February 5, 2016

Re: The Fields at Sherborn - Comprehensive Permit Application  
Sewer and Water Systems Review Update

# The Fields Washington Street Sherborn, MA

Figure 1. Groundwater Contours Derived from Bruce Saluk Data for Low Groundwater.

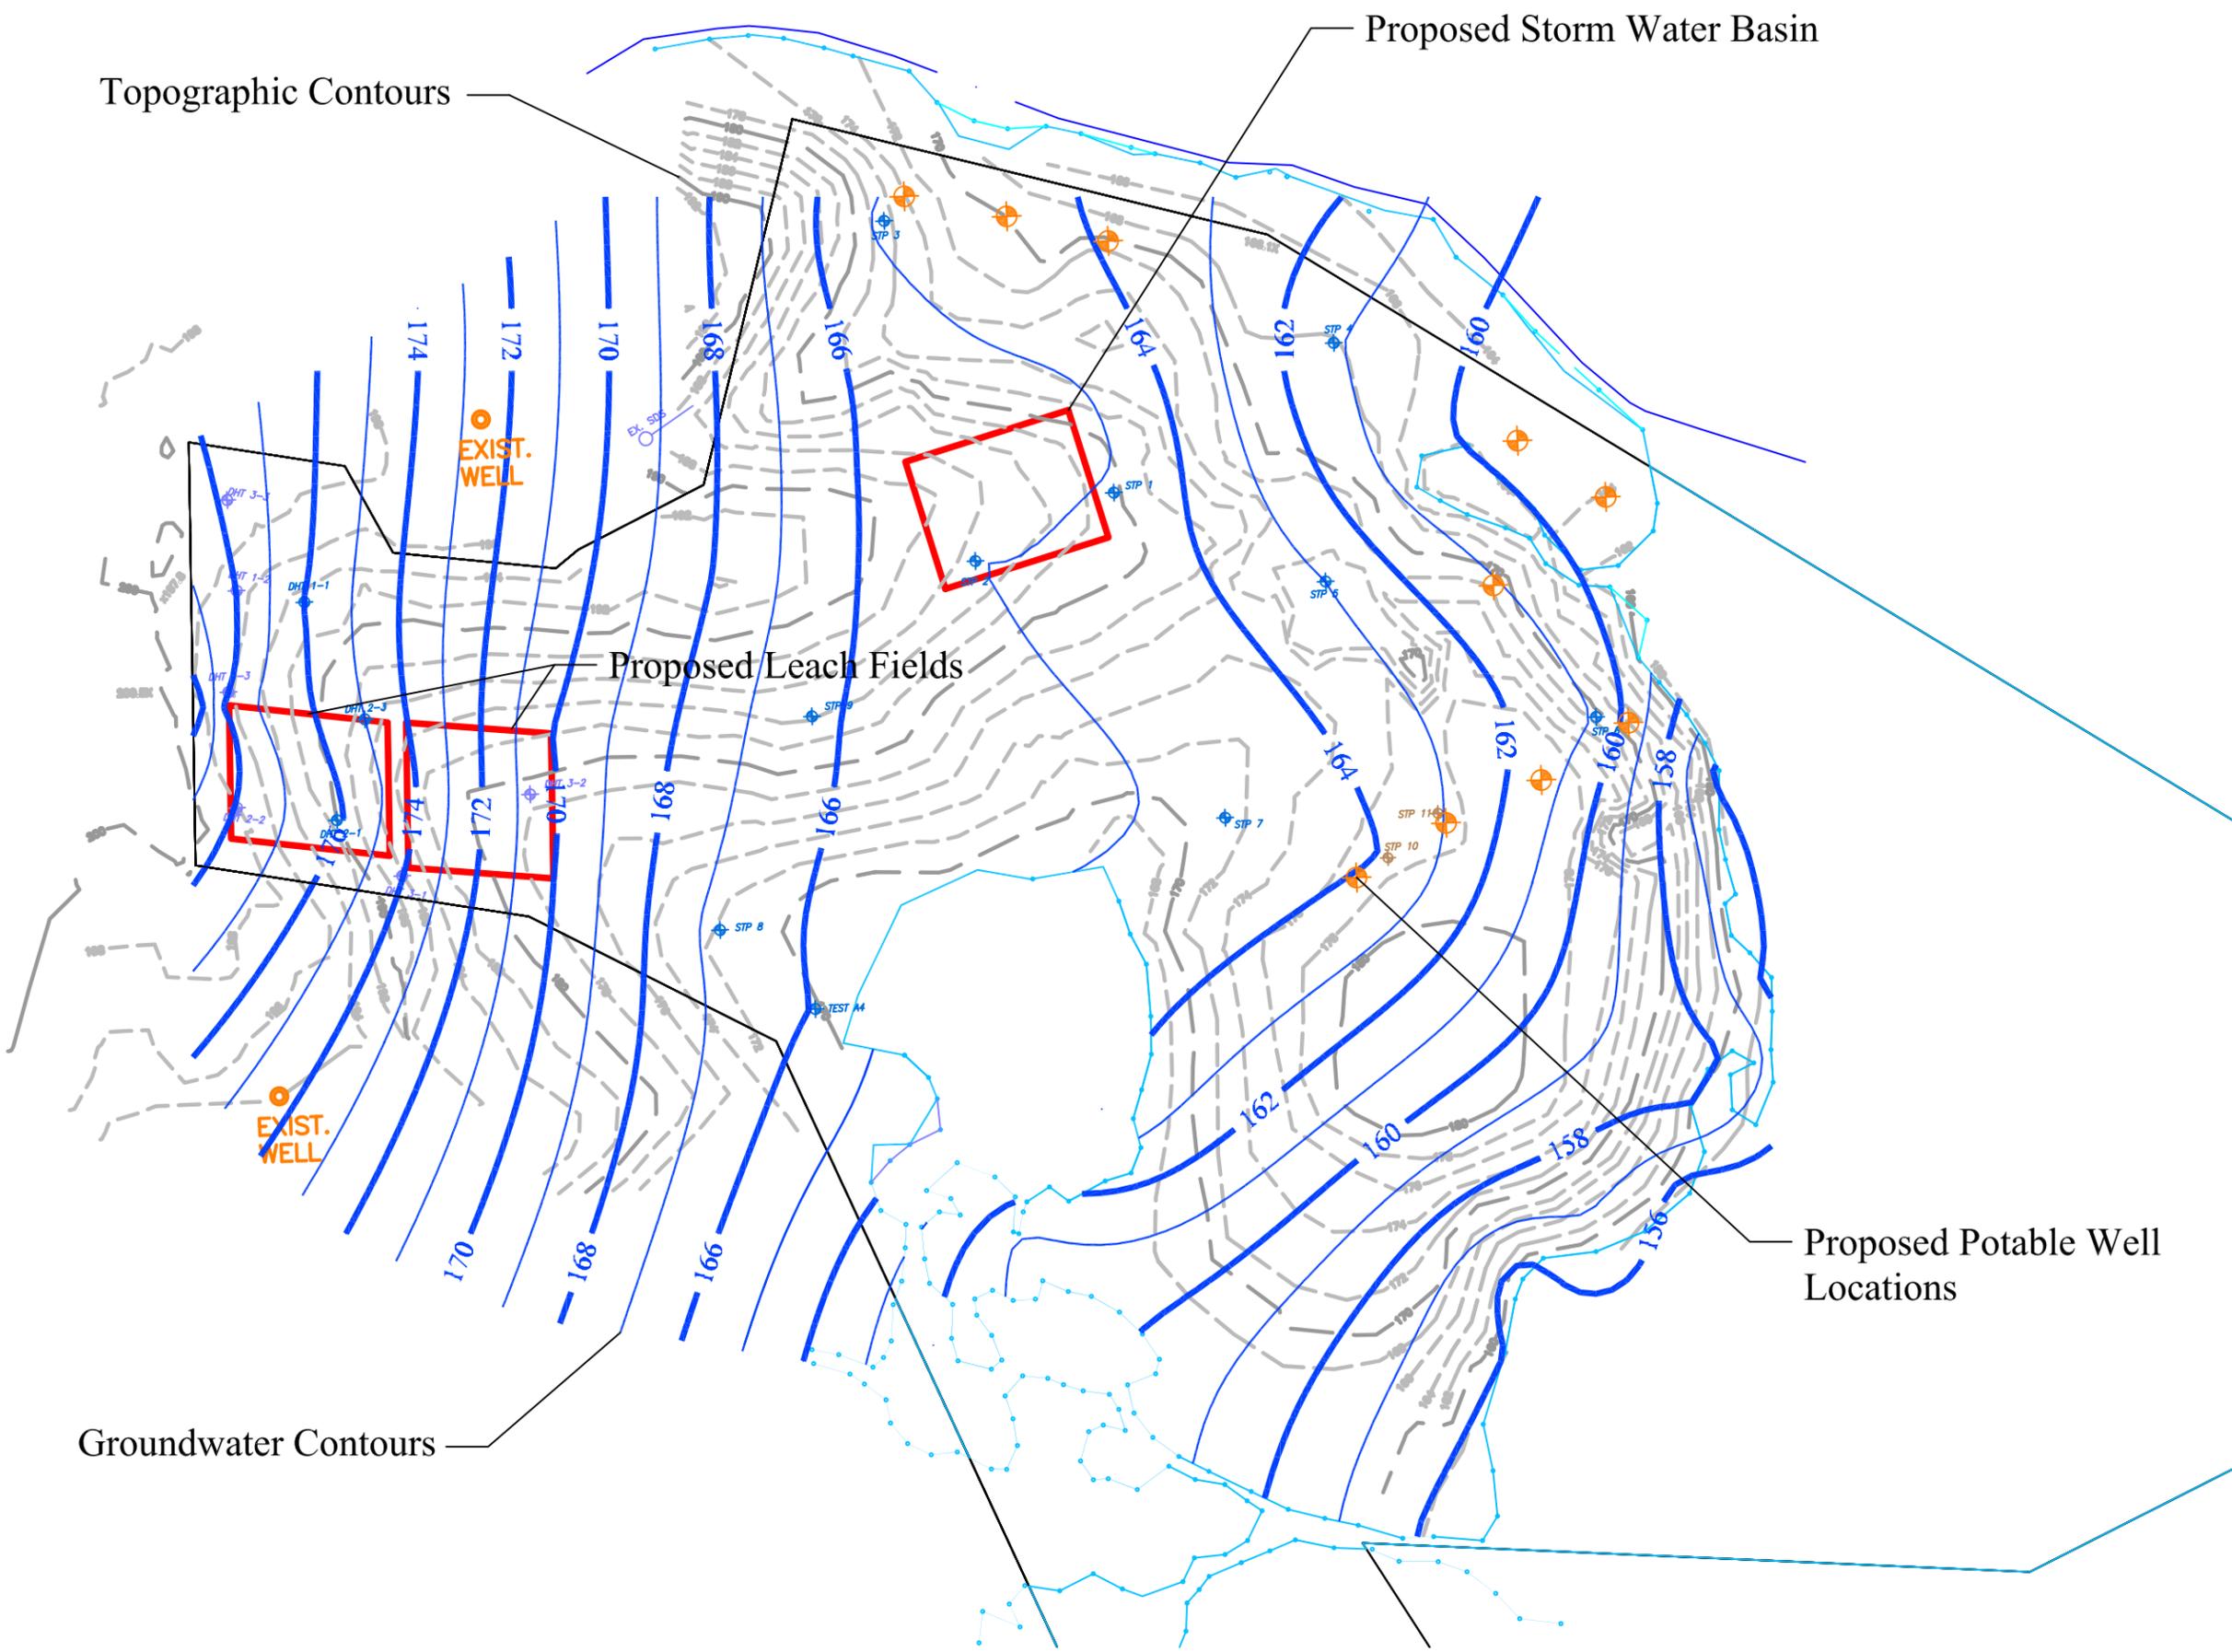
- GW6. *Provide the groundwater flow direction and slope of the water table beneath the property. DT: Please find the attached groundwater profile drawing. BETA2: Provide a revised groundwater contour map, excluding the data from wells DHT-23 and STP-1. See 10/1/15 BETA Memorandum. DT3: Please find the revised groundwater contour Plan. BETA3: The DT has provided a groundwater contour map showing an Estimated Seasonal High Groundwater (ESHGW) and groundwater contours representing a time of year when groundwater is lower. However, the DT AOI/Plume delineations show ESHGW at lower elevations than the wetlands (see W11 and W12 recommendations). BETA4: A review of the groundwater data provided by the Design Team was completed and two independent figures showing groundwater contours were developed using the DT data. Figure 1 shows contours of Low Groundwater, and Figure 2 shows contours of High Groundwater.*

*The current AOI figure based on contours of high and low groundwater provided by DT was compared to the contours in Figures 1 and 2 and no significant differences were found. Based on this comparison, the resulting AOI for high and low groundwater reasonably represent groundwater flow under those conditions.*
